Statement

Product Name: Wi-Fi & Bluetooth Module
Model Number: FCM363X
Hardware Version: R1.0, R1.1
Software Version: FCM363XAAR02A02M08

Model Number: FCM363X-L
Hardware Version: R1.0

FCM363X (R1.1) TOP

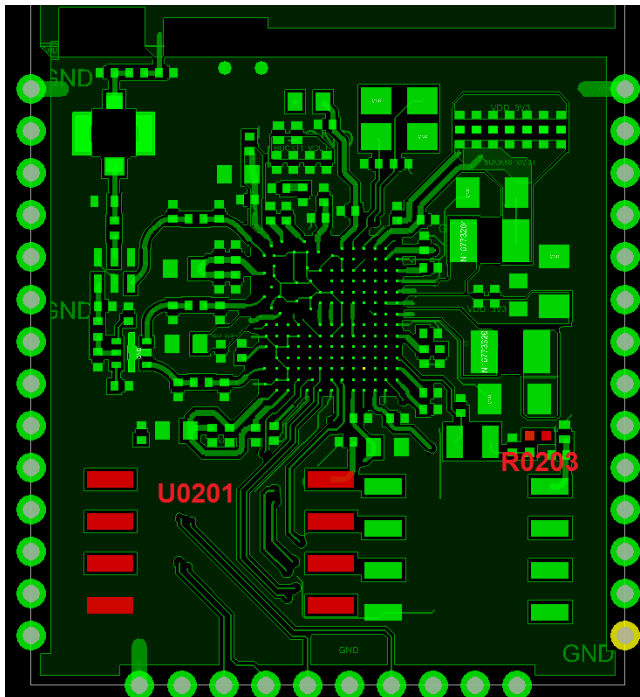
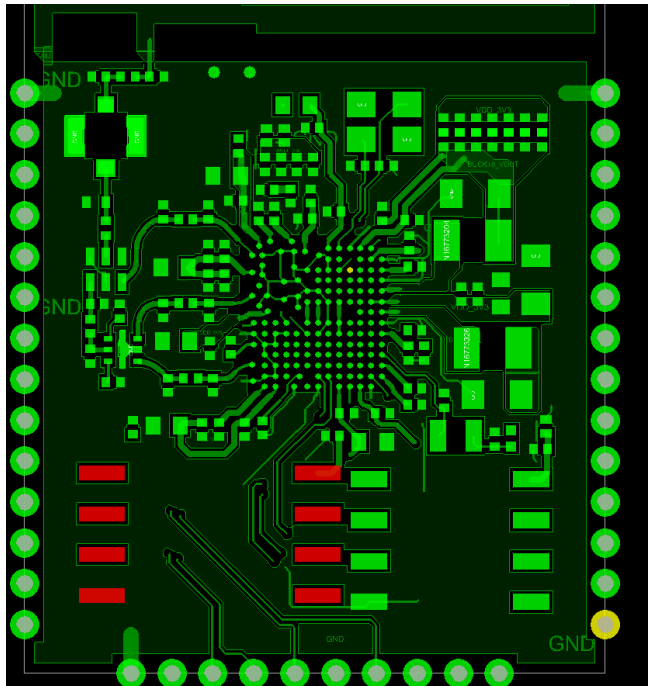
- **SMT Differences**

| Designator	FCM363X (R1.1) (Part Description)	FCM363X (R1.0) (Part Description)
X0202	Has	Delete
C0204	Has	Delete
C0205	Has	Delete
R0203	Delete	Has
R0204	Has	Delete
U0202	Has	Delete
C0206	Has	Delete
C0207	Has	Delete

FCM363X (R1.0) TOP   FCM363X-L TOP

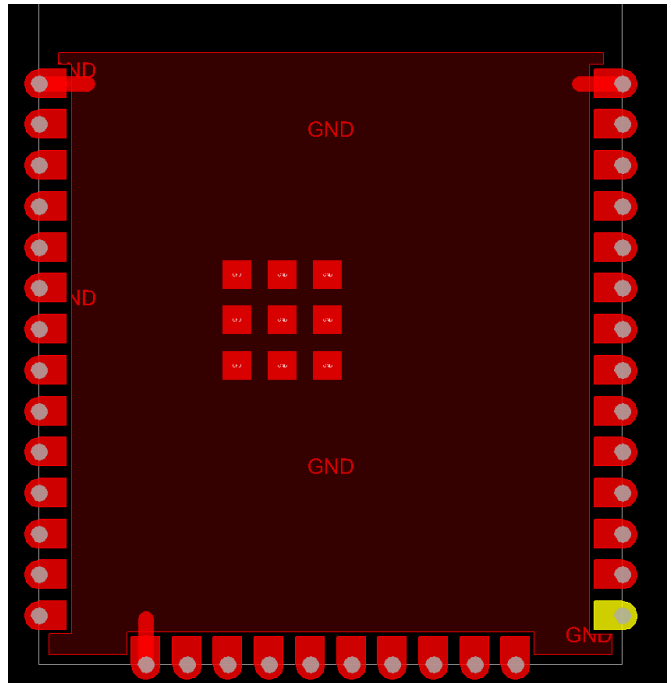
- **PCB Layout changes**

Designator	FCM363X (R1,0) (Part Description)	FCM363X-L (Part Description)
R0203	Has	Delete
U0201	8MB flash is XM25QH64DHIQT, Manufacturer is XMC	8MB flash is MX25L6433FM2I-08G, Manufacturer is MXIC
PCB	Has 38 LCC pins and 35 LGA pins	Has 38 LCC pins and 9 LGA pins(LGA 39~64 pins deleted)
PCB	The module PIN25 is connected to the D4 pin of the RW610 chip.	The module PIN25 is connected to the U4 pin of the RW610 chip.
